# Post-Occupancy Evaluation of the Wayman Tisdale Specialty Clinic

*April 7, 2013*

## Executive Summary

Lobby without shades

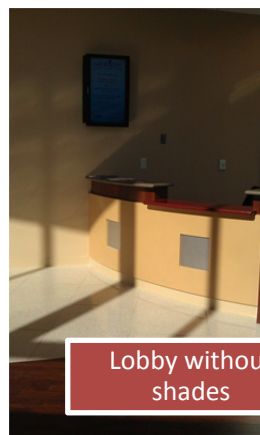
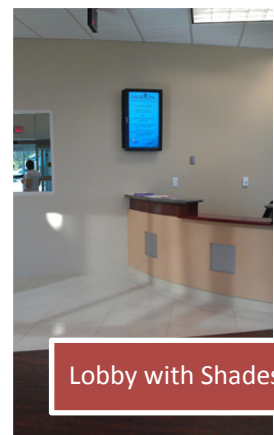
The light levels in the unaltered state ranged from a low of 85 footcandles to a high of 2,149 footcandles with three points over 1,000 footcandles and 10 points under 300 footcandles. Under altered conditions, the light levels were significantly lower ranging from 78 footcandles to 204 footcandles. The recommended illuminance range for the lobby is 2 to 50 footcandles with the higher value only recommended for performing visual tasks of a large size. All readings greatly exceeded the desirable illuminance.

Lower the window shades in the afternoons to reduce glare and overall illumination levels.

Access Points

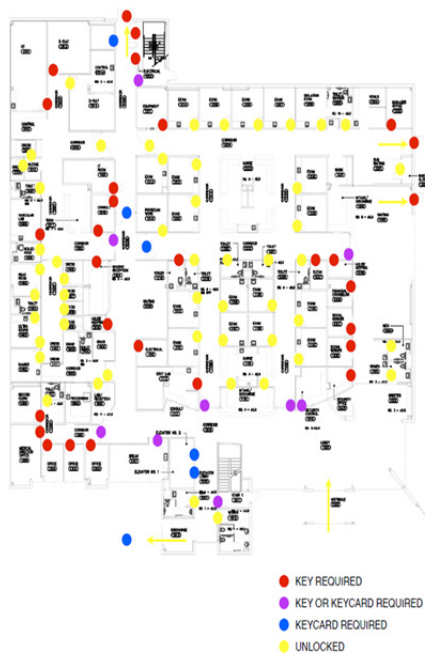
Only five doors were unlocked and open to the public, four doors to restrooms and one door to the laboratory and blood draw area. The rest of the doors were adequately secured by key or card key.

The laboratory and blood draw area needs a lock activated by card key or button located at the check-in desk.
